To: Garry Pape, PE
From: Jeff Walton, Associate Planner; 910-341-3260
CC: File; Protrak
Date: 1/14/2013
Re: Jordan Lake Townhomes

JORDAN LANE TOWNHOMES
 Wilmington New Hanover County North Carolina

SITE INVENTORY PLAN

Sheet No. **C-2.1**

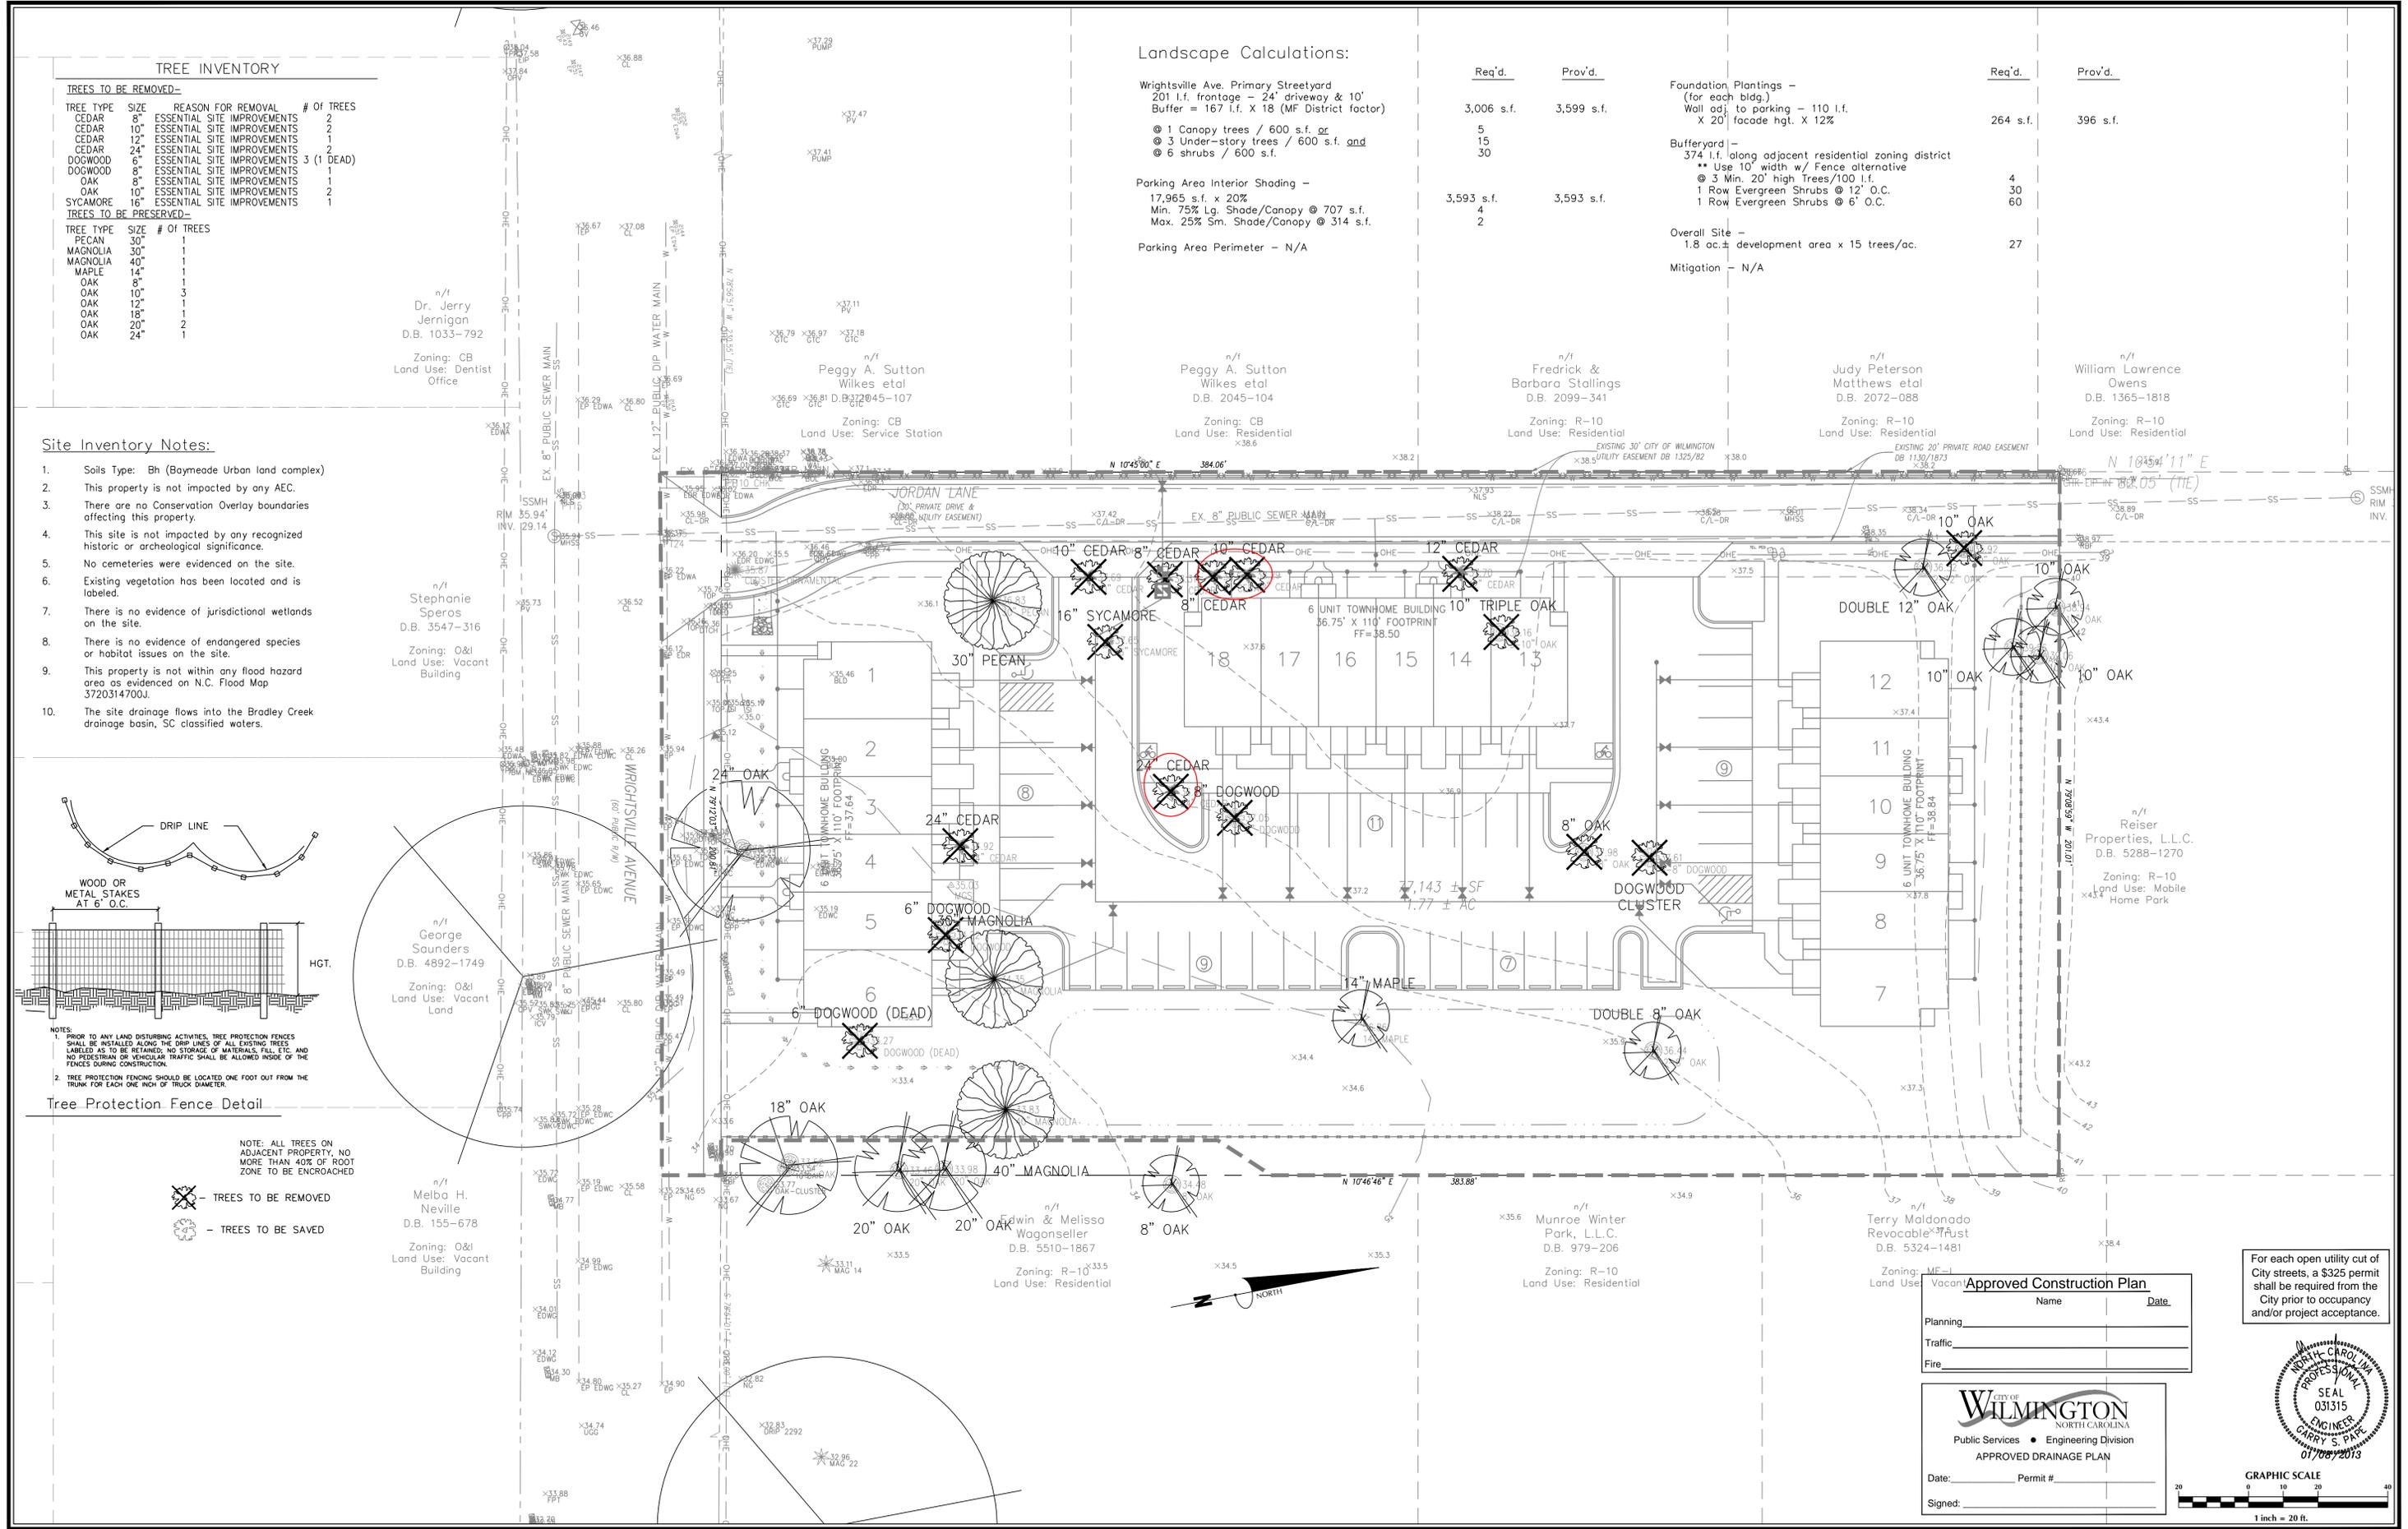
- Show dumpster detail and fencing.
- A tree preservation/removal permit is required
 - Attached is a plan of questionable trees to be removed. It appears the site could be modified to save these three trees.
